TOWN OF NISKAYUNA
Planning Board and Zoning Commission

Agenda

August 29, 2022

Nott and Balltown - ATM
38100P375091

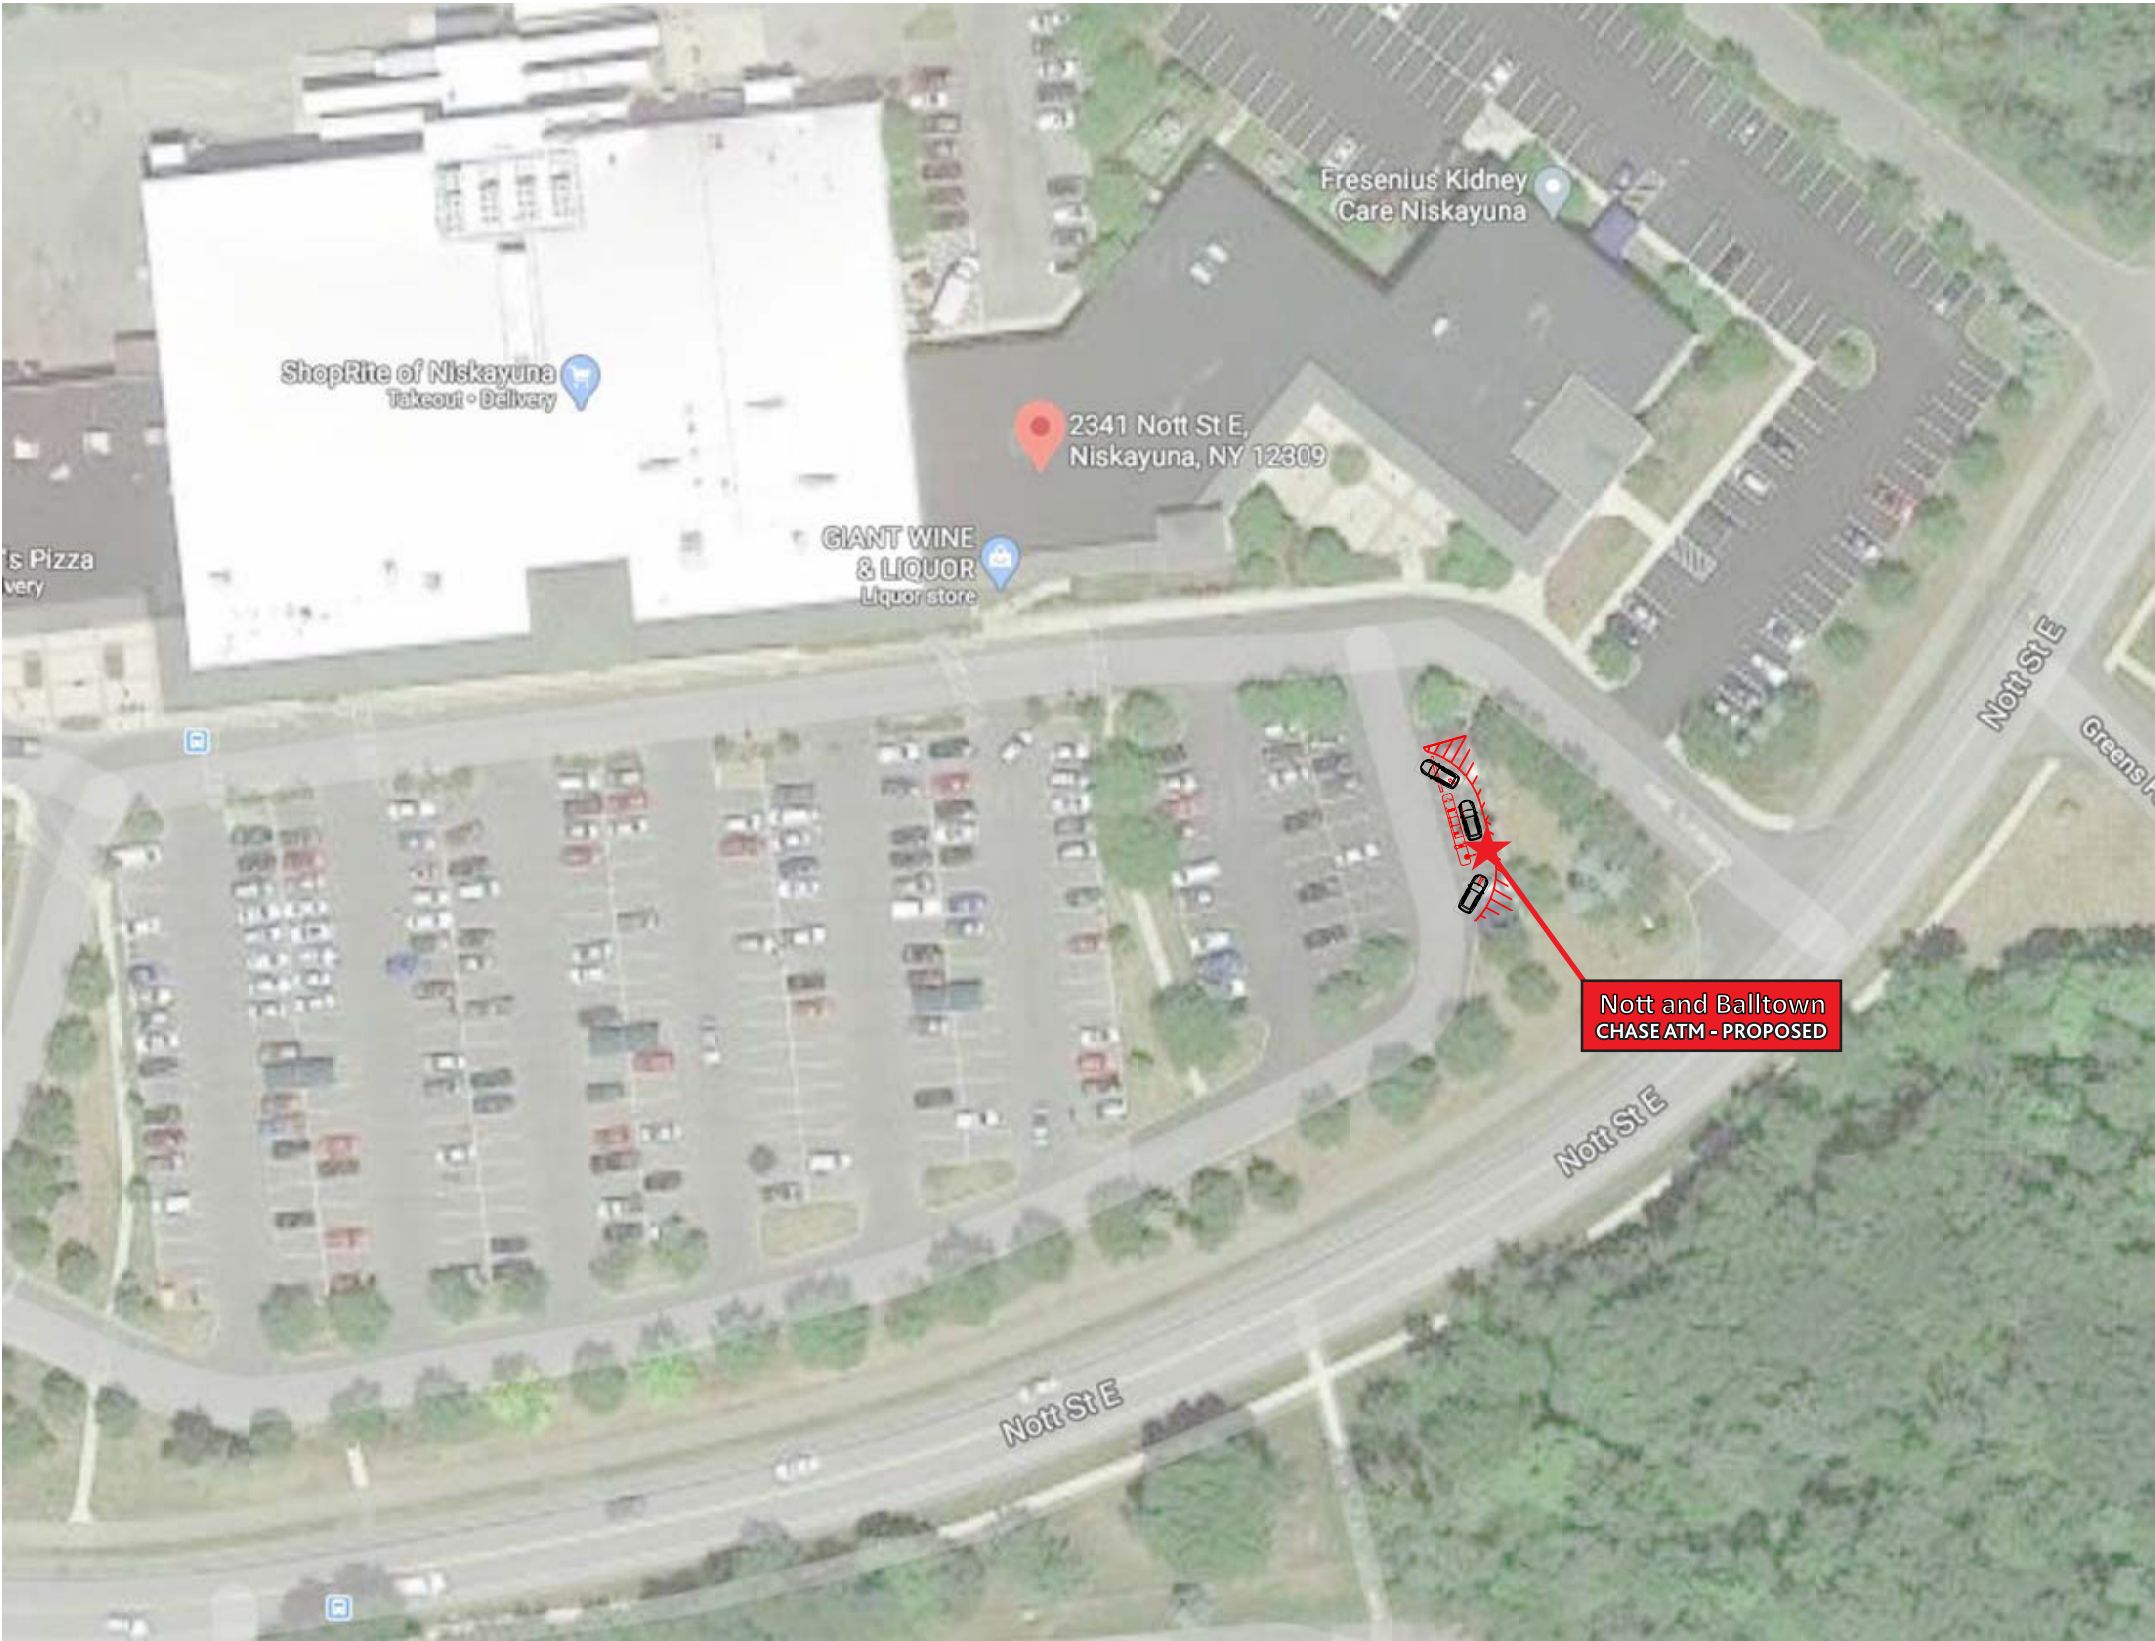
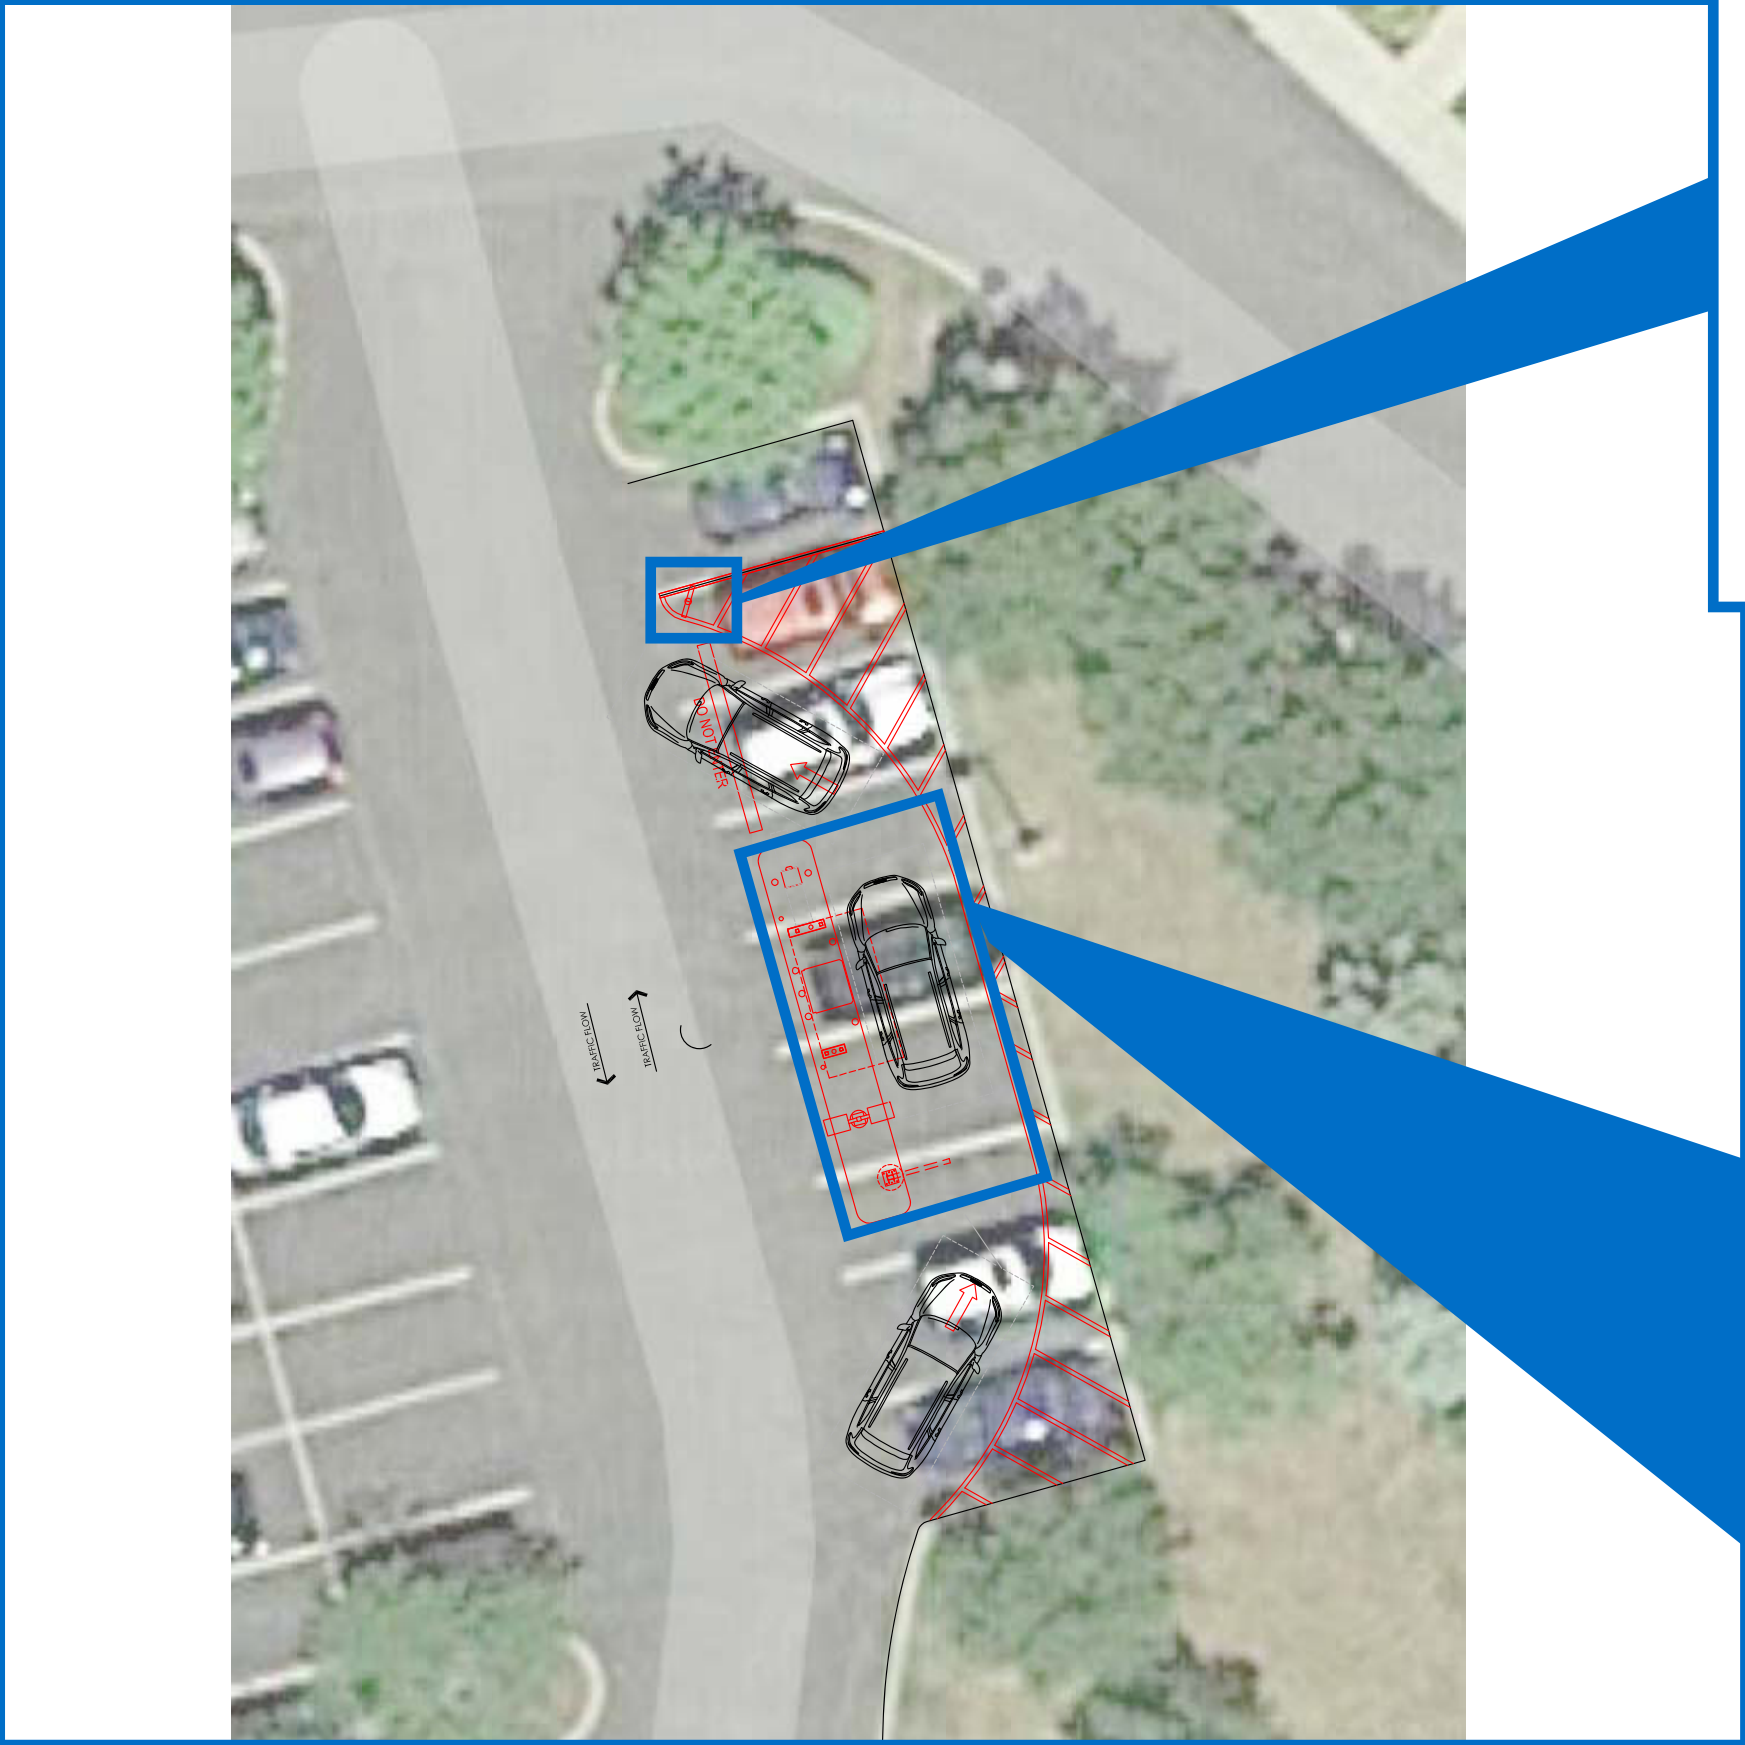
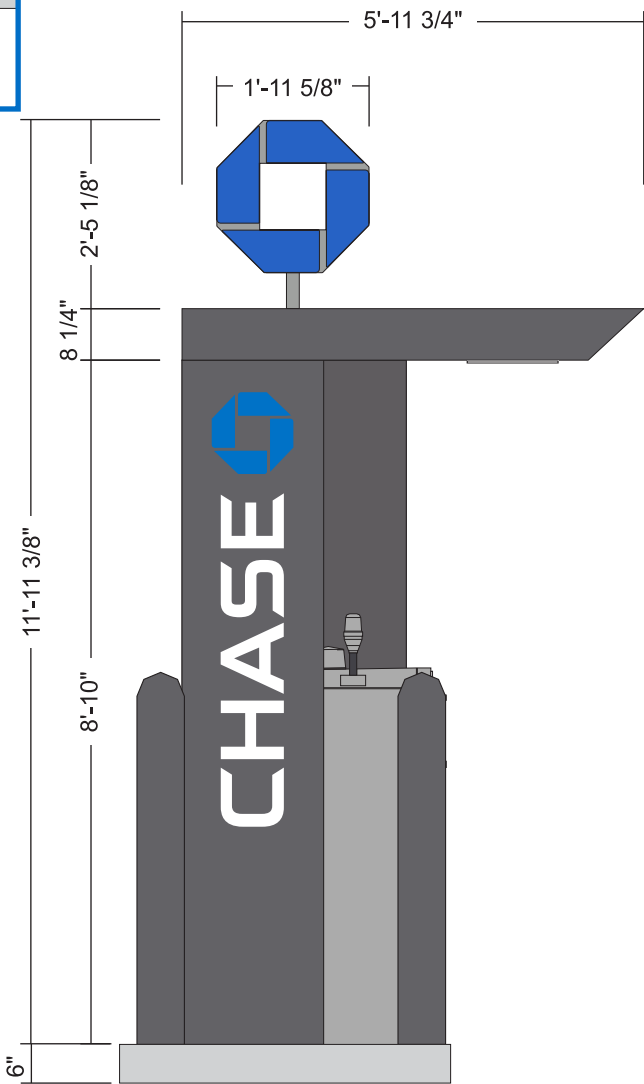
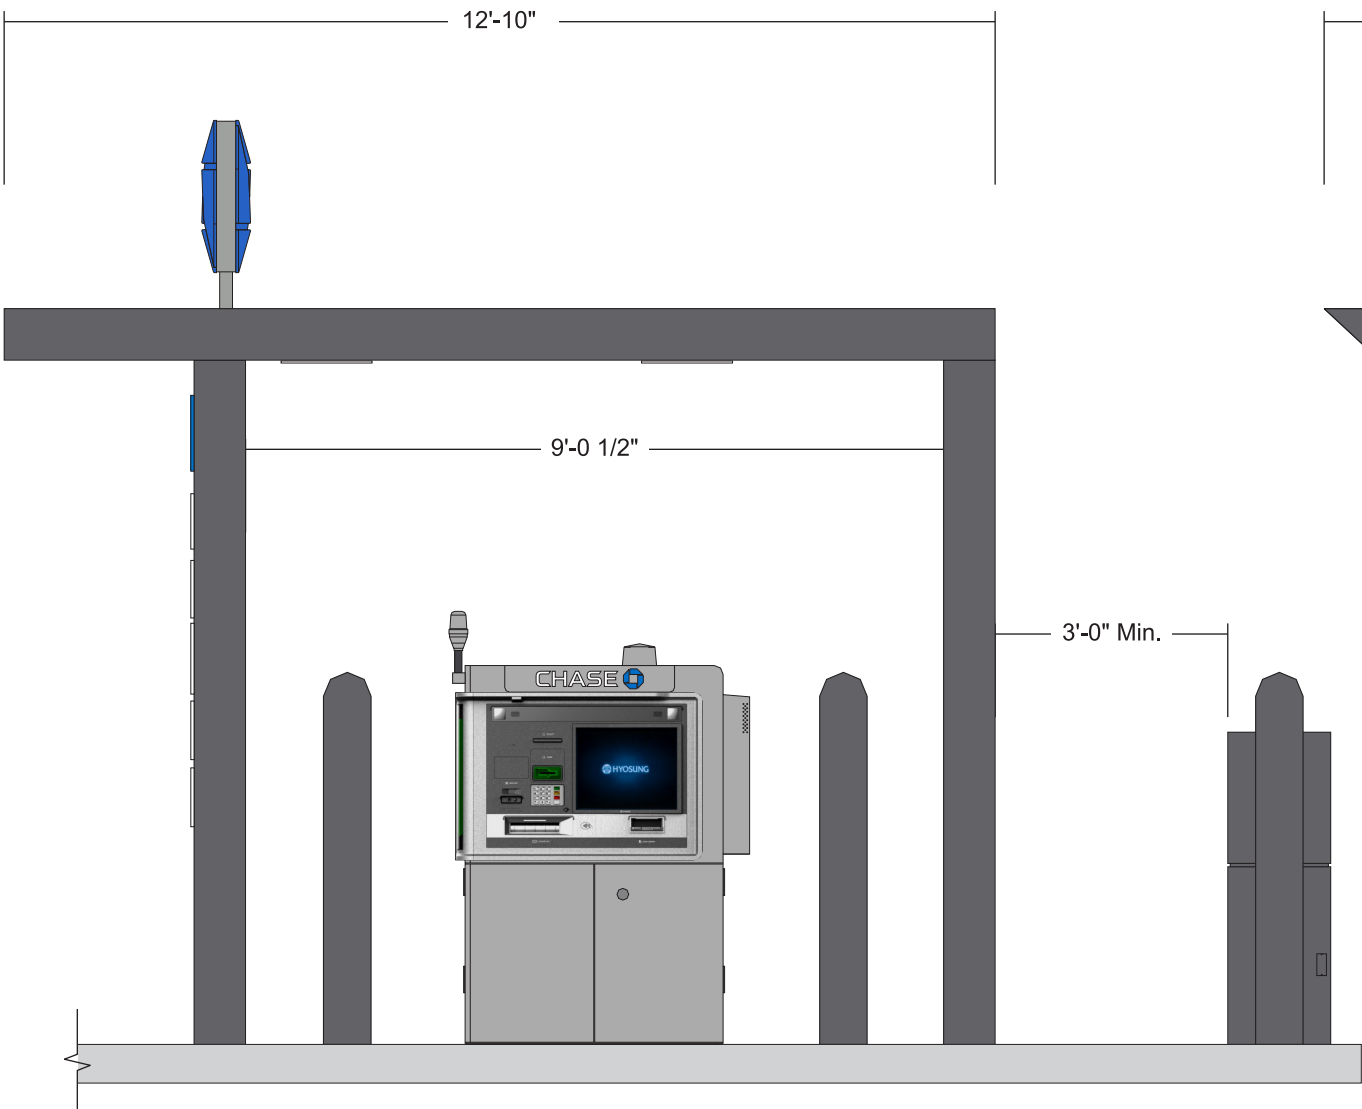
Pages A102, A103 and A104 of the aforementioned drawing set include design details for the proposed ATM. Several portions of the ATM station infrastructure and associated graphical displays should be reviewed by the Board relative to the requirements set forth in Section 220-4 of the zoning code. The drawings include a "non-illuminated signage option" that reads "CHASE" followed by the Chase Bank logo on one of the canopy legs.

Section 220-48.4 Signs E Minimum performance criteria (5) Logo states: "In the event that a picture logo is displayed on a sign, it shall be incorporated into the permitted sign area to comprise not more than 30% of the sign area". As proposed, the drawings show a two-sided "non-illuminated octagon signage option" located above the aluminum "signature canopy" that partially shields the ATM machine from weather. The logo comprises 100% of the sign area so a waiver for a sign with a logo covering 100% of the sign area may be required.

WHEREAS, Zoning Code Section 220-48.4 Signs Minimum performance criteria (5) Logo states: "In the event that a picture logo is displayed on a sign, it shall be incorporate into the permitted sign area to comprise not more than 30% of the sign area". As proposed, the drawings show a two-sided "non-illuminated octagon signage option" located above the aluminum "signature canopy" with a logo comprising 100% of the sign area. Therefore, a waiver for a sign with a logo covering 100% of the sign area is required, and

RESOLVED, that the Planning Board and Zoning Commission has determined that the proposed waivers would have a minimum negative effect on aesthetics and does hereby grant said waivers as outlined above, and be it

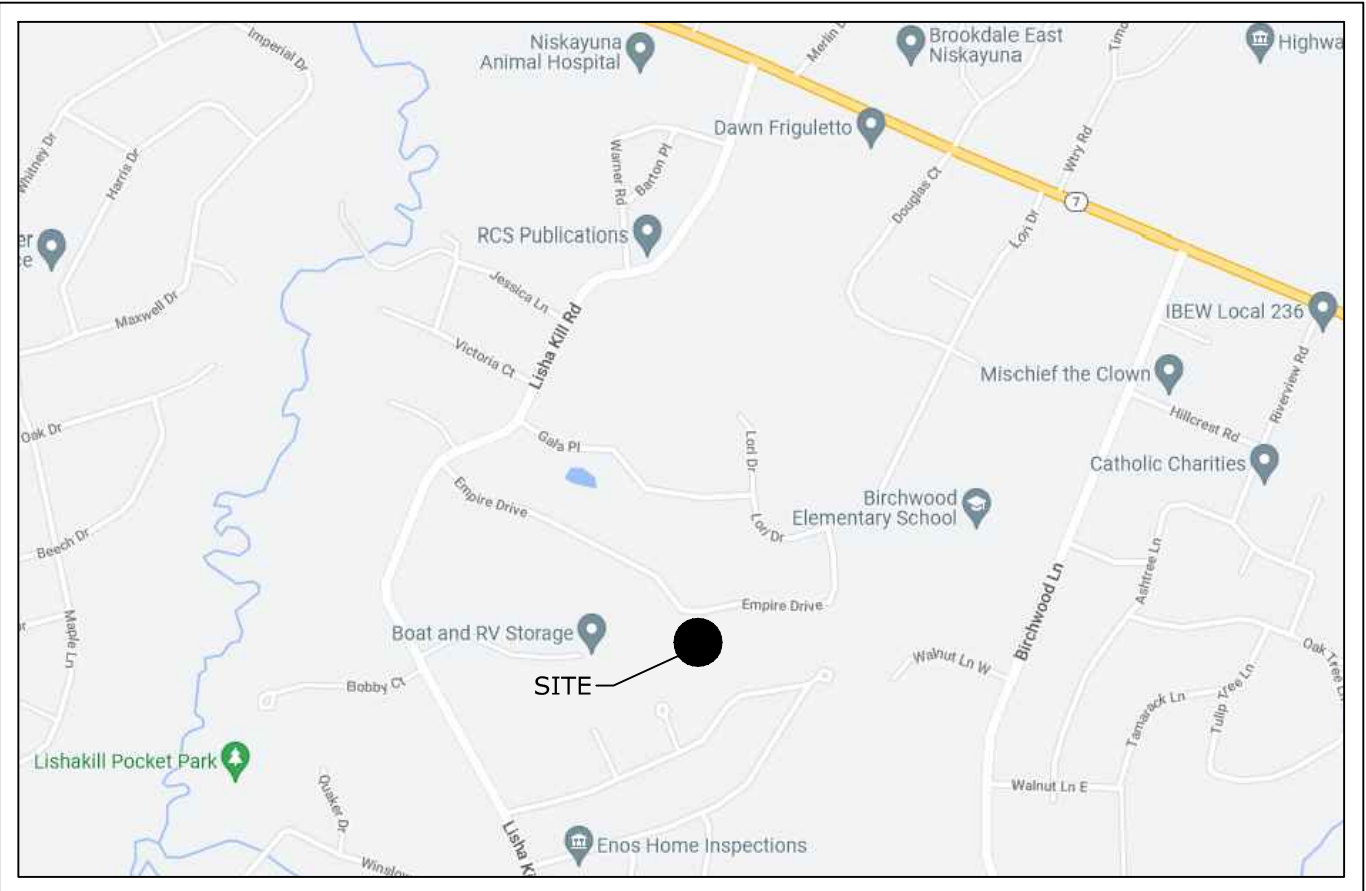
1. Require an easement on lot 1 for a potential future multi-use path that would connect the large forest to the northwest of the lot to Empire Dr. and destinations to the east such as Birchwood Elementary School.
2. Keep the limits of clearing as small as possible so that as many mature trees as possible may be preserved.

8/8/22 Planning Board (PB) meeting – Resolution 2022-17 was approved granting approval of the sketch plan, calling for a public hearing to be held at the 8/29/22 PB meeting and directing the Town Planner to file a Negative SEQR declaration with the following 2 conditions.

1. An easement for a potential future multi-use path is to be included in the site plan drawing
2. Limits of clearing are to be kept as small as possible & as many mature trees as possible are to be preserved.
